BOARD ACTION REPORT – APPEALABLE ITEM

Project Name: 125 Dixie Boulevard (2020-180)
Project Location: 125 Dixie Boulevard, Del-Ida Park Historic District
PCN: 12-43-46-09-29-004-0241
Request: Certificate of Appropriateness & Variance
Board: Historic Preservation Board
Meeting Date: October 7, 2020
Board Vote: Approved on a 5-0 vote

HISTORIC PRESERVATION BOARD STAFF REPORT

125 Dixie Boulevard

A2.0

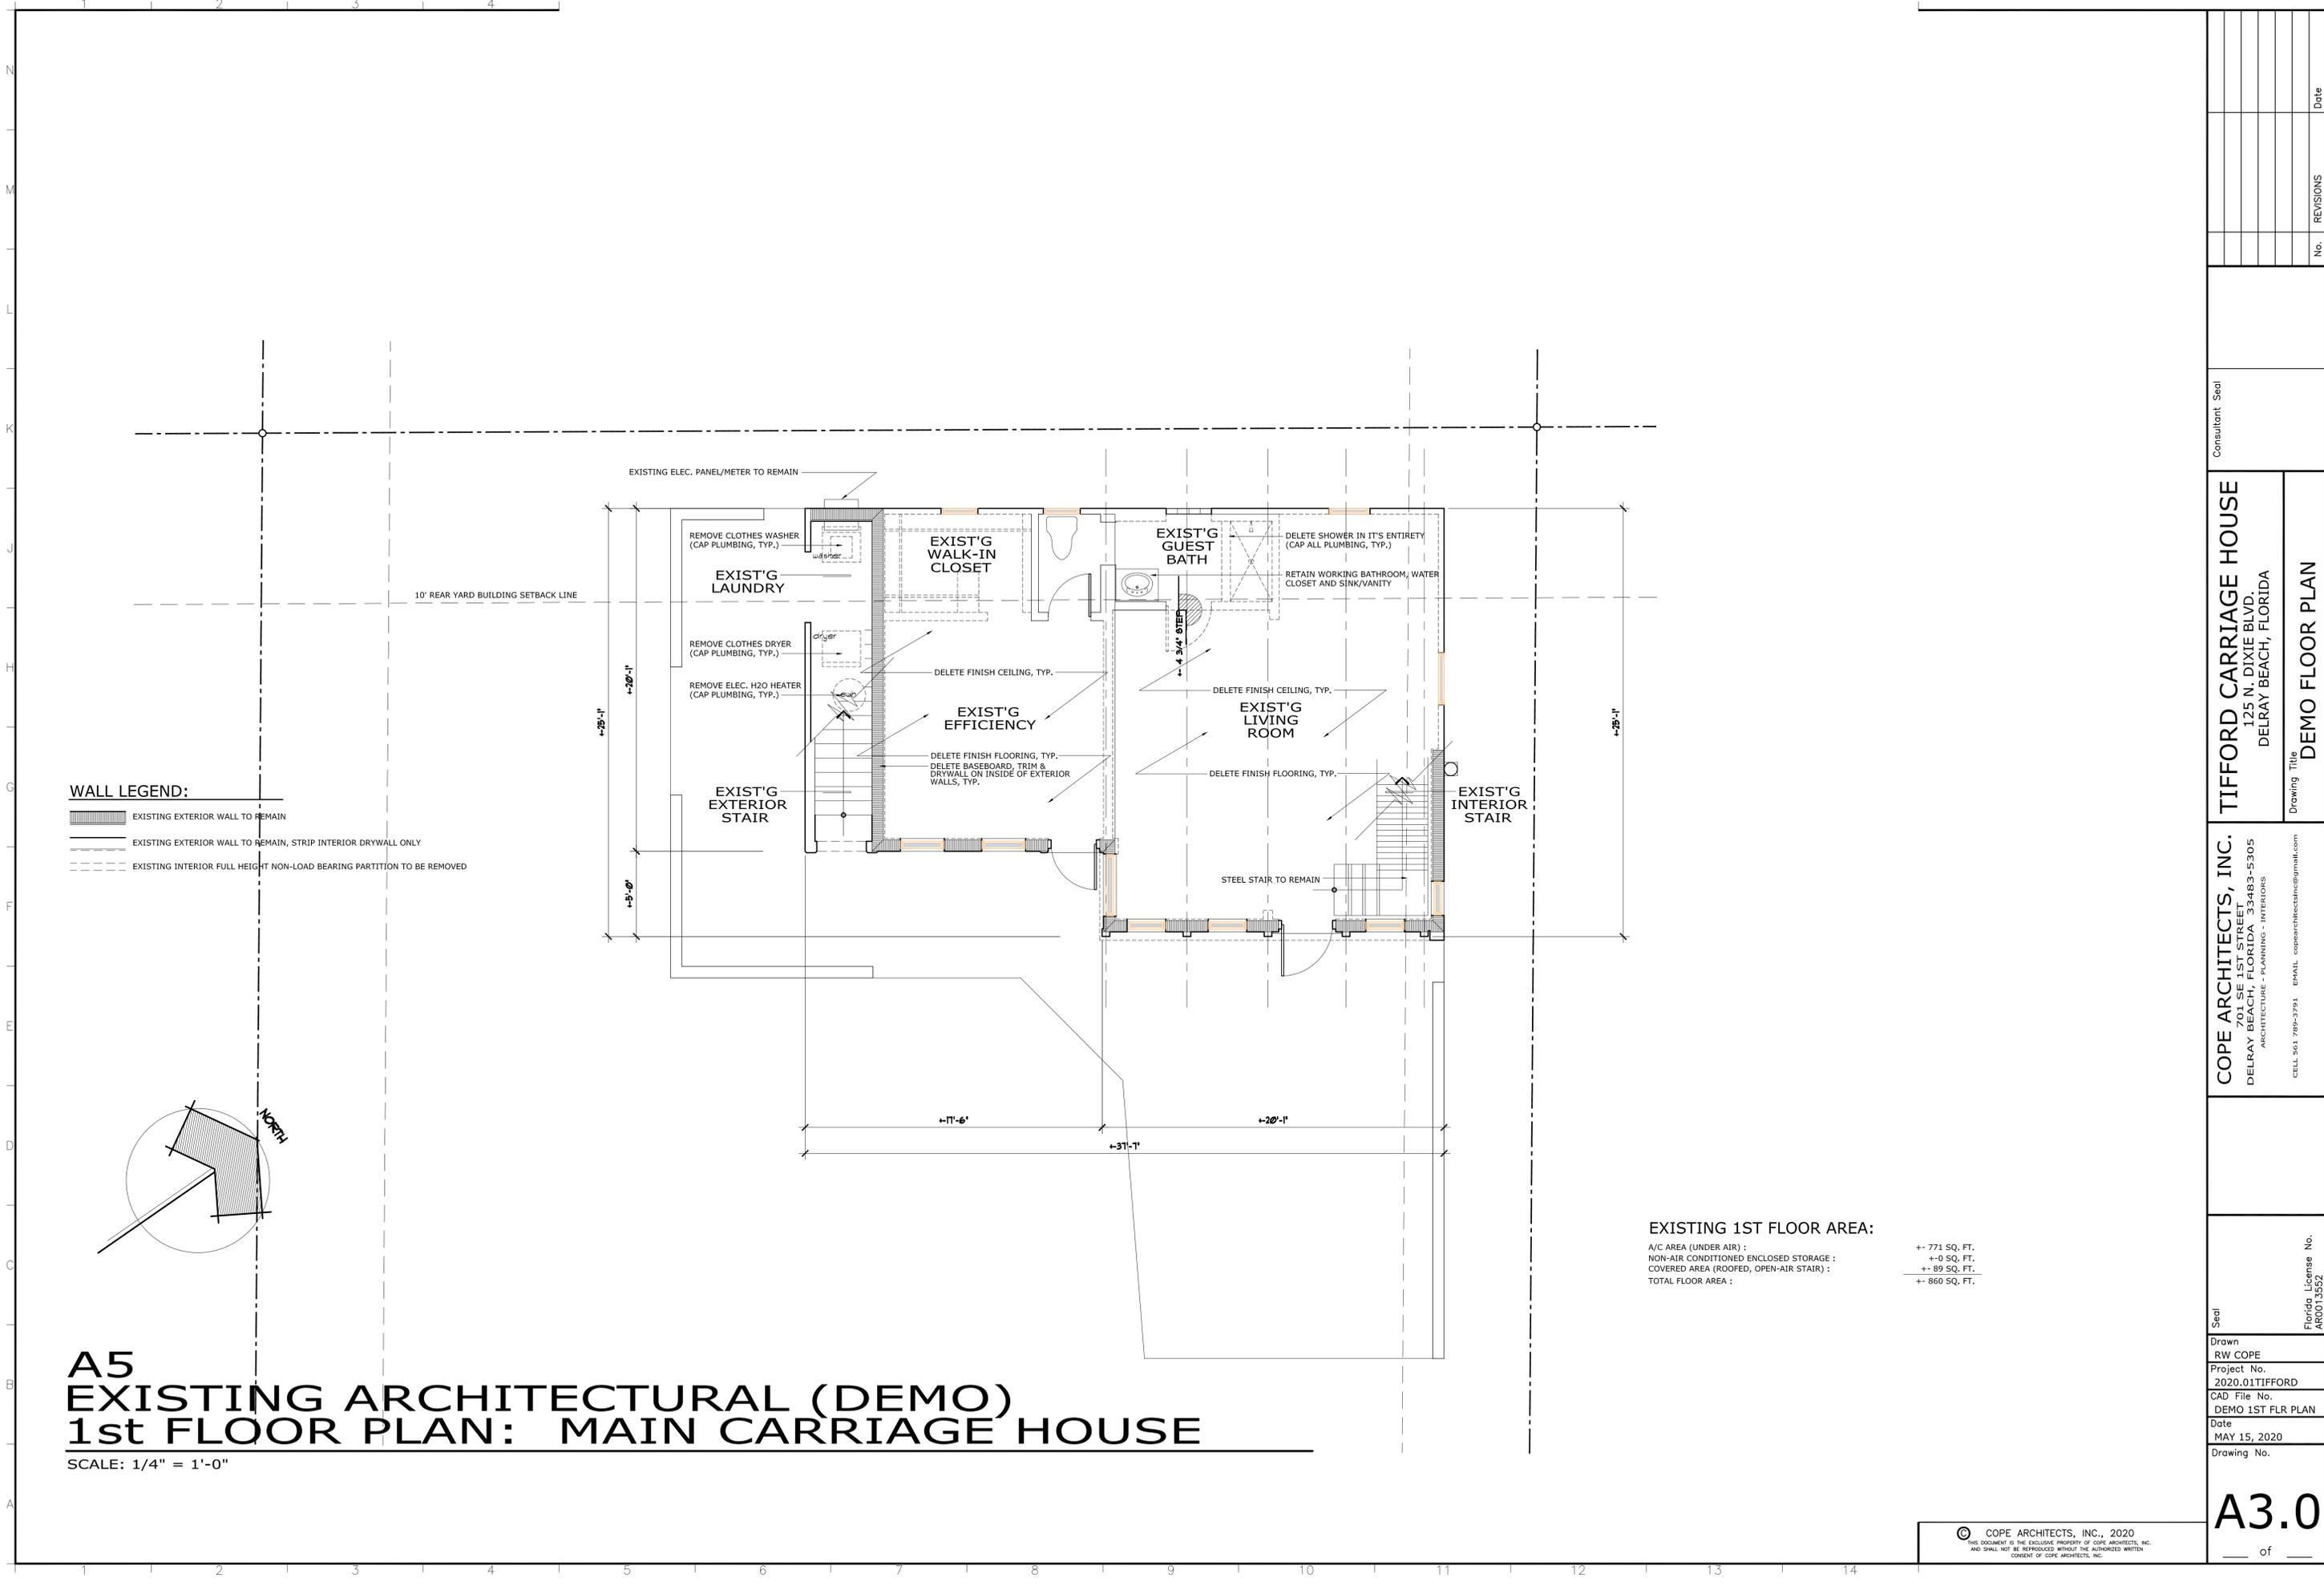
A swimming pool is proposed in the front of the property and will meet the requirements of this code section. As an added condition of approval, is that the required and provided setbacks for the proposed swimming pool be included in the Site Data Chart on plan sheet A2-0.

- that the required and provided setbacks for the proposed swimming pool be included in the Site Data Chart on plan sheet A2-0
 - That the existing floor square footage total on Sheets A3.1 and A4.1 be revised to reflect the correct calculations.
 - Provide an existing site plan layout and a composite overlay layout; these can be on the same plan sheet.
 - Remove the word “demo” from the title Sheet A3.0 & A3.1 from plan sets
 - Provide setback ranges for proposed plan (Sheet A2.0)
- D. Deny Certificate of Appropriateness (2020-180) & Variance, for the property located at **125 Dixie Boulevard, Del-Ida Historic District**, by finding that the request is inconsistent with the Comprehensive Plan and does not meet the criteria set forth in the Land Development Regulations.
